JAFP-20-0047

James A. FitzPatrick Nuclear Power Plant
Renewed Facility Operating License No. DPR-59
NRC Docket No. 50-333

SUBJECT: License Amendment Request – Application to Modify Technical Specifications 3.6.1.3, “Primary Containment Isolation Valves”

One Line Diagram

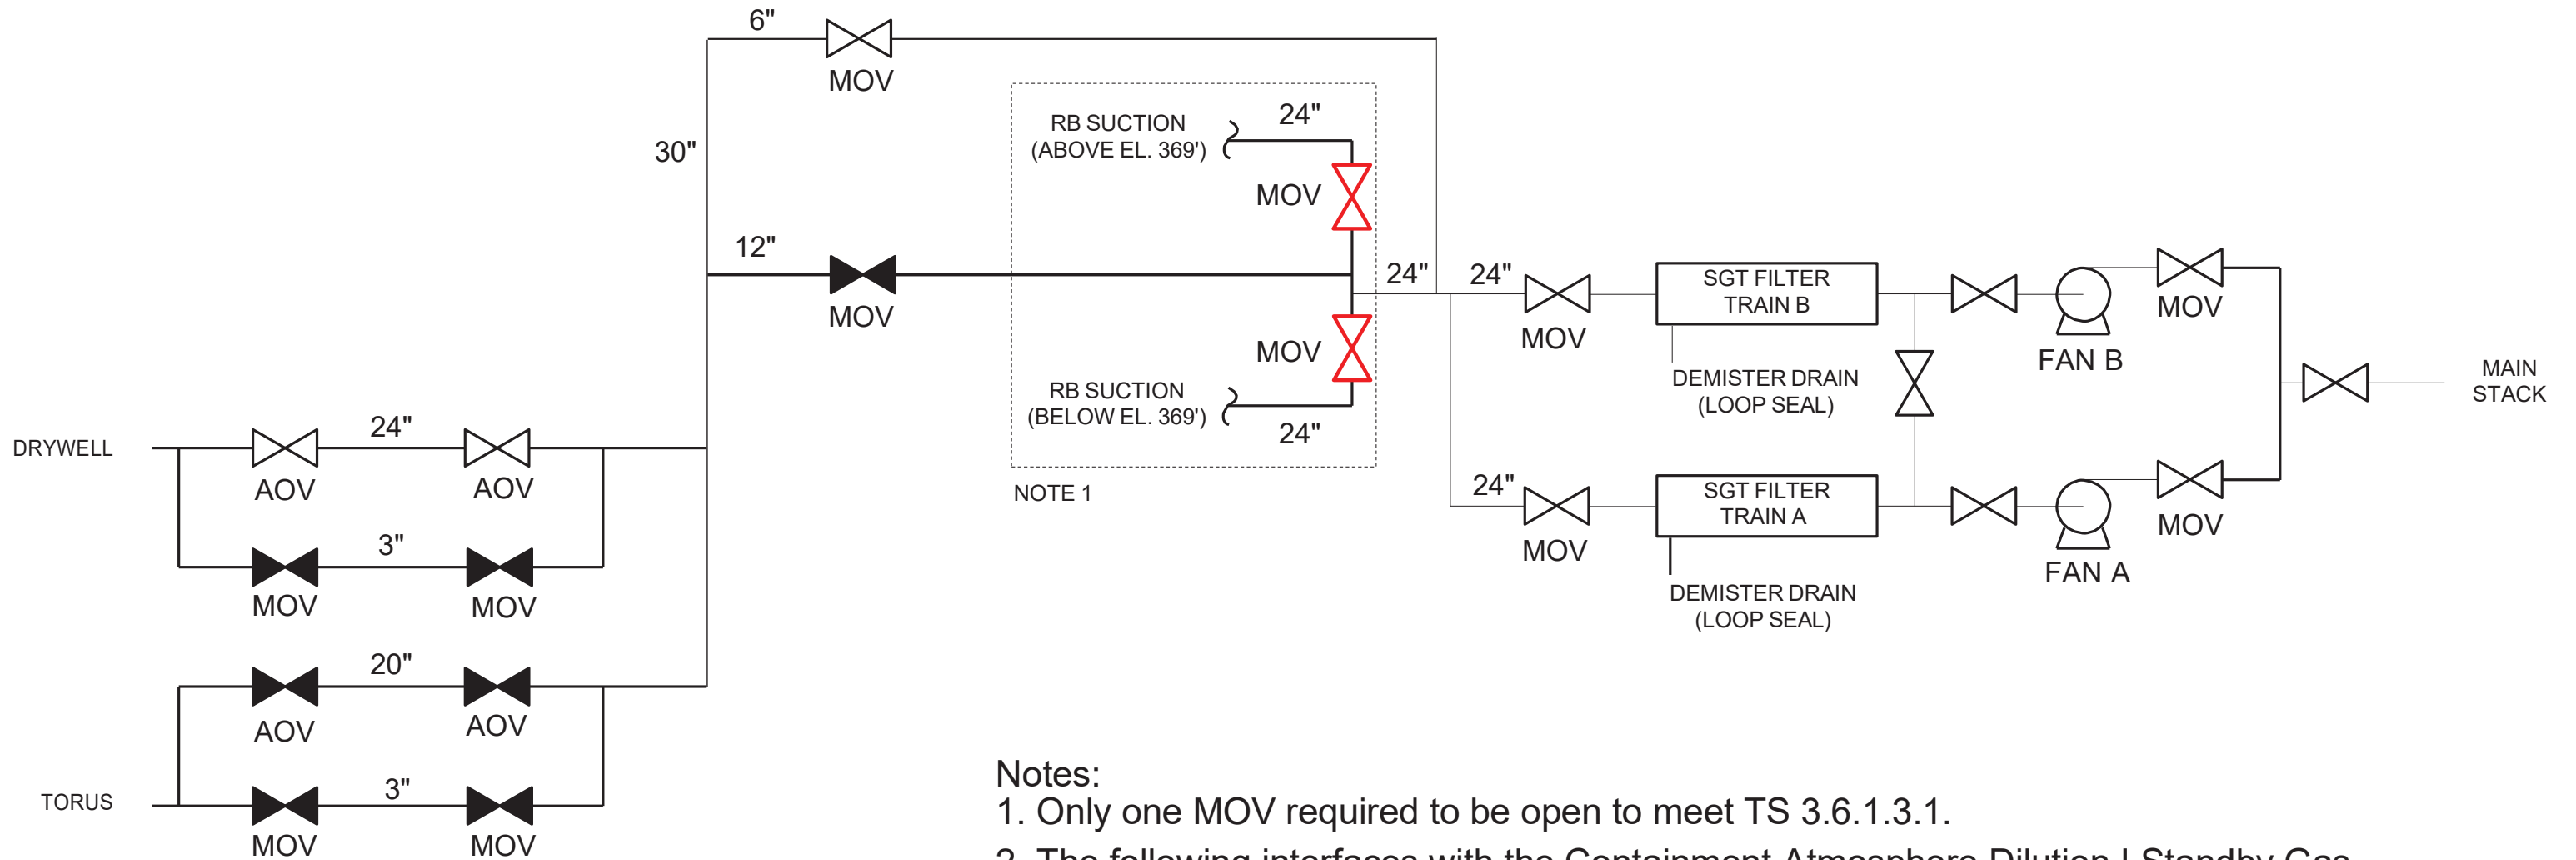
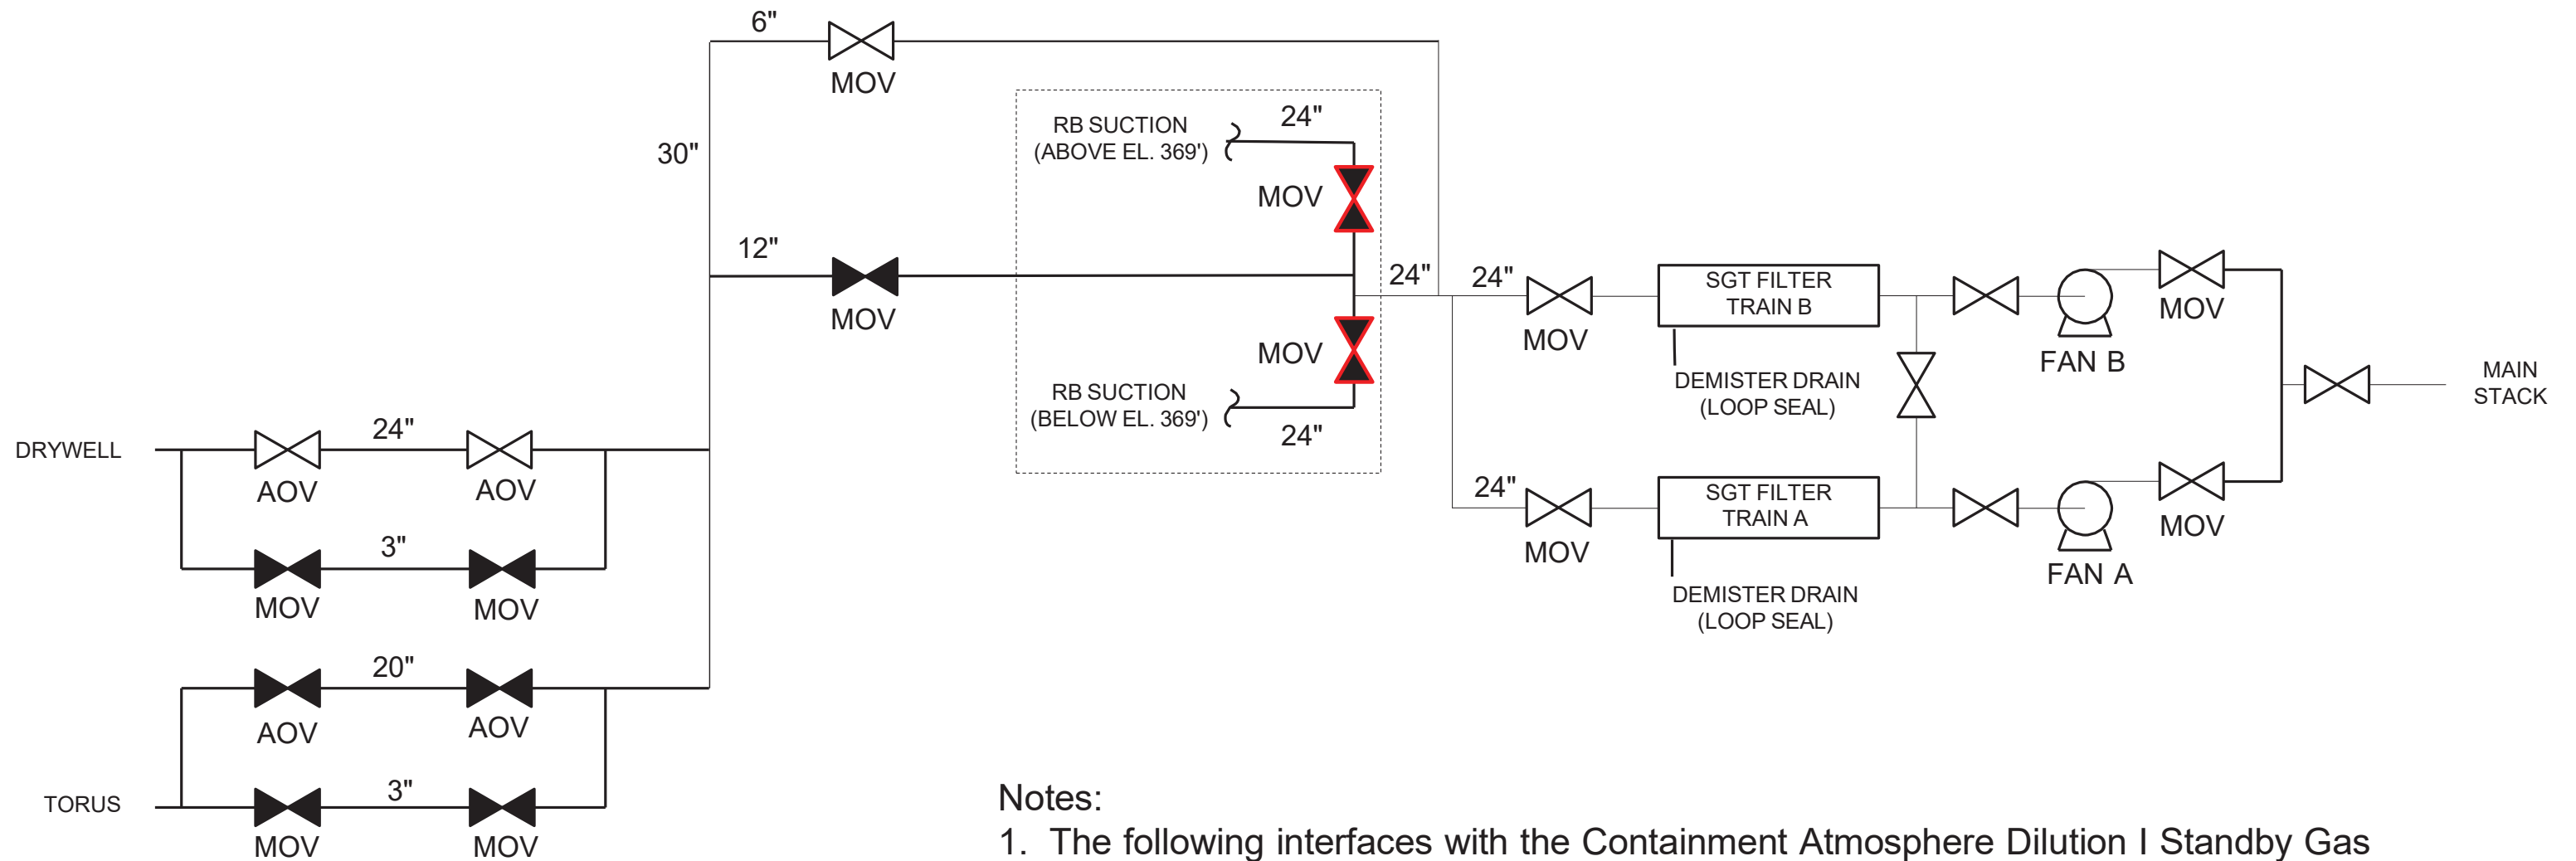
The proposed change is to continue to align the containment vent path through the 6-inch pathway but closing the SGT reactor building suction valves. While the flow through the SGT system remains approximately the same, the new proposed lineup would route flow from the primary containment only thereby reducing the containment venting time by half.

1. Case 1 considers the current operating valve lineup in which 01-125 MOV-12 is open when Standby Gas Treatment System (SGTS) Train B is operating, i.e., at the time a LOCA is postulated to occur. See Attachment 5, Figure 1.
2. Case 2 considers 01-125-MOV-12 to be closed at the time a LOCA occurs, and to open subsequent to the LOCA. See Attachment 5, Figure 2.

In pursuit of using the Case 2 operational alignment (Attachment 1, Figure 2), the original analysis was reviewed to identify Case 2 analysis refinements which may eliminate or reduce the potential for a field modification to the demister loop seals. The following details are refinements to the Case 2 analysis:

*-----Note-----
"Not required to be met when the 20 inch and 24 inch primary containment vent and purge valves are open for inerting, de-inerting, pressure control, ALARA or air quality considerations for personnel entry, or Surveillances that require the valves to be open, provided the full-flow line to Standby Gas Treatment (SGT) System is closed."*

SBGT Component	Acceptance Criterion	Case 2 Previous Result*	Case 2 Reanalysis Result*	Conclusion
HEPA B Filter Inlet	1.0 psig	0.89 psig	0.52 psig	Limit Not Exceeded
HEPA B Filter Outlet	0.79 psig	0.74 psig	0.45 psig	Limit Not Exceeded
HEPA B Filter Pressure Drop	8.0 inches H ₂ O	6.73 inches H ₂ O	5.0 inches H ₂ O	Limit Not Exceeded
Reactor Building Pressure Rise	0.28 psi	0.024 psi	0.06 psi	Limit Not Exceeded
Demister Loop Seal	18 inches H ₂ O (see below)	24.6 inches H ₂ O	14.4 inches H ₂ O	<i>Limit No Longer Exceeded</i>
